Item (9) Refer to Architectural Drawings, Sheet A2.31 - Building 300 Floor Plans. REMOVE replacement of existing window glazing (Reynolds 212) for windows on north side of Kindergartens (301 and 302) from the scope of work for this project.

MODERNIZATION
FOR
COLONEL HOWARD NICHOLS SCHOOL
3401 RENEGADE AVE.
BAKERSFIELD, CA. 93306
BAKERSFIELD CITY SCHOOL DISTRICT

BUILDING 300 FLOOR PLAN AND REFLECTED CEILING PLAN

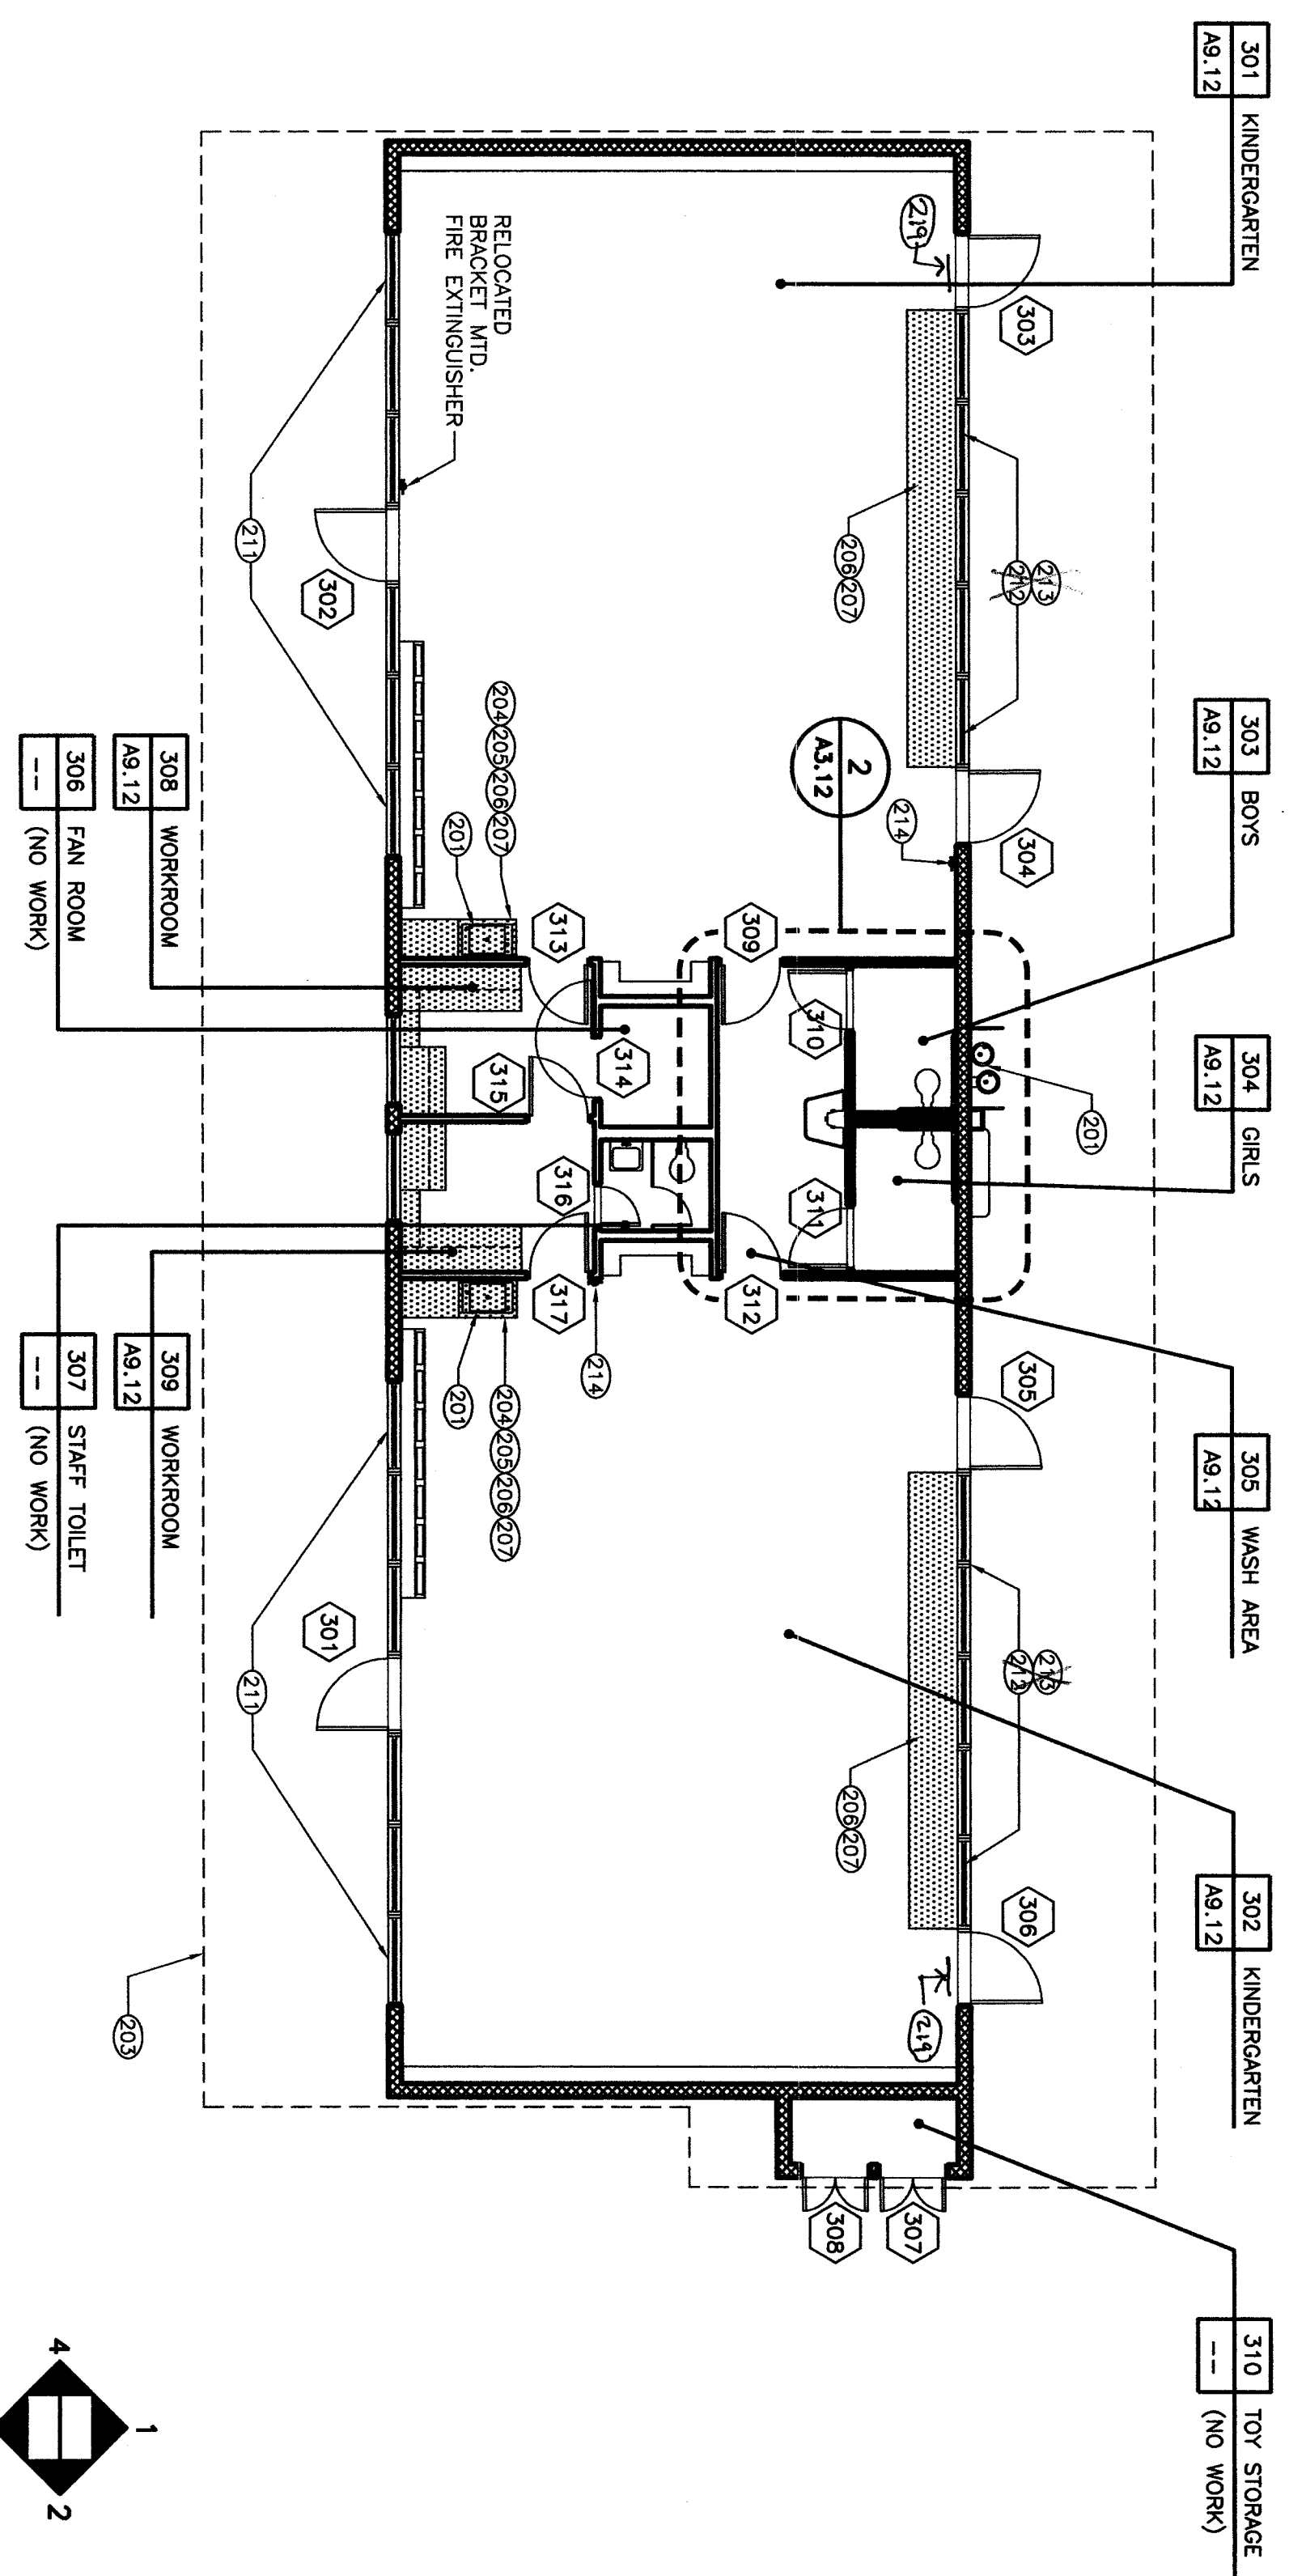
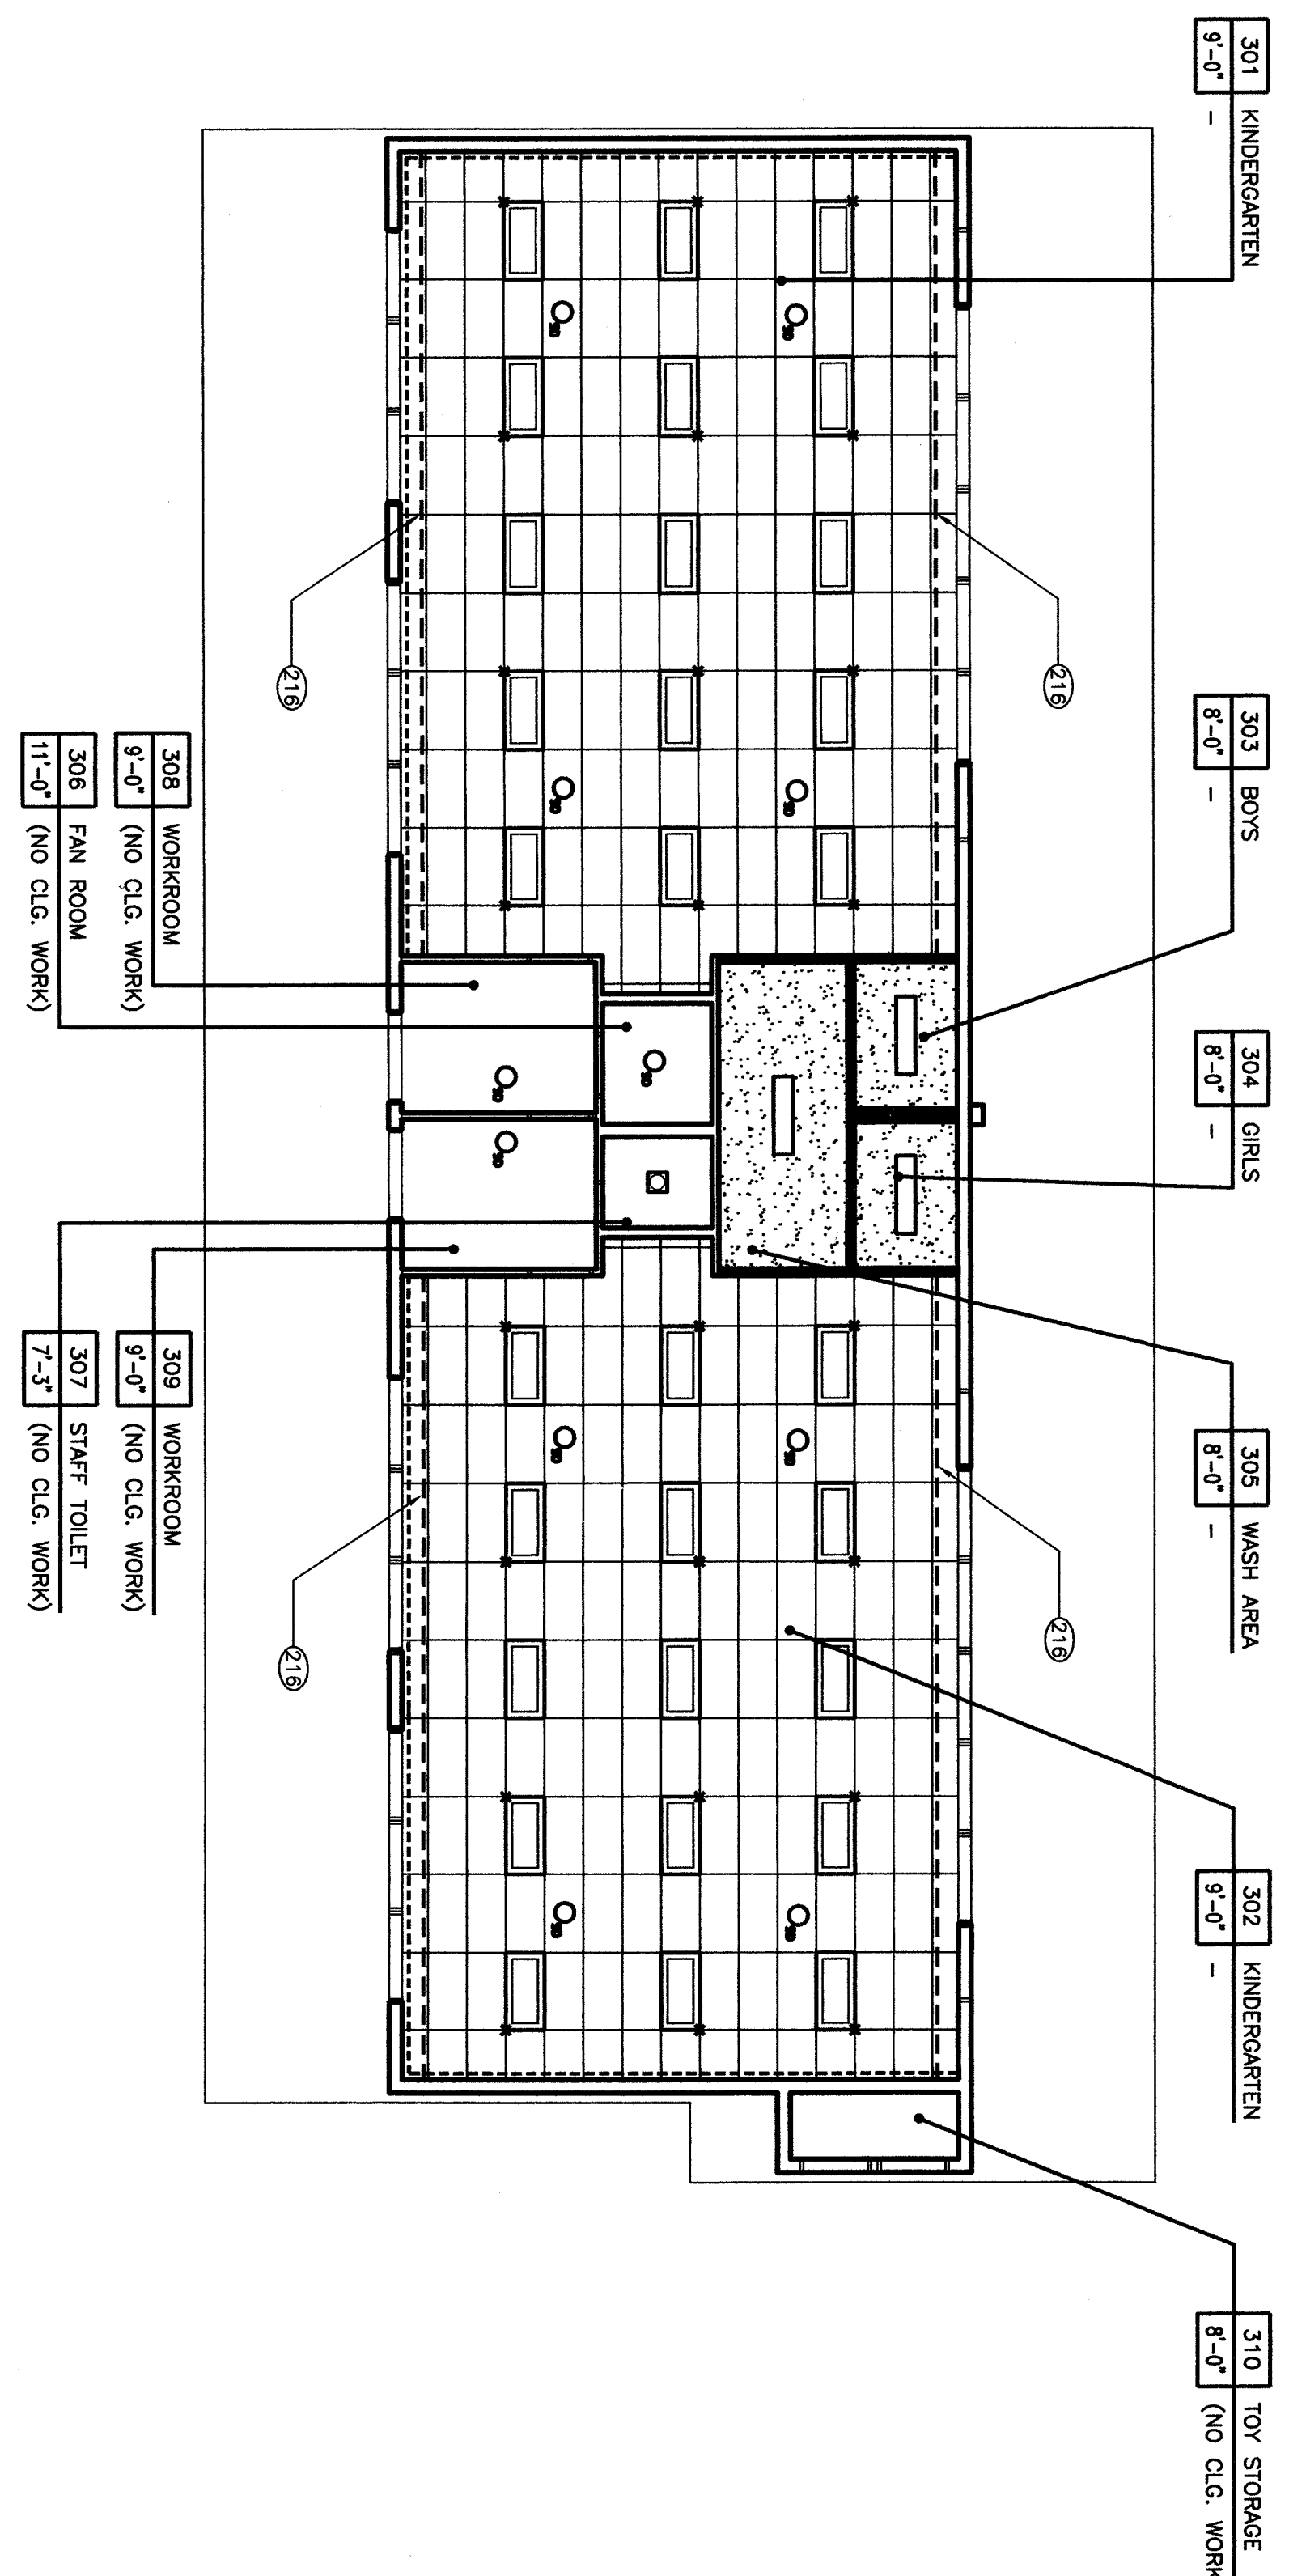
Item (9) Refer to Architectural Drawings, Sheet A2.31 - Building 300 Floor Plans. CLARIFY layout of floor materials (carpet and VCT) in Kindergarten (301) and Kindergarten (302) as shown on attached Drawing A21-01, dated 11/27/07.
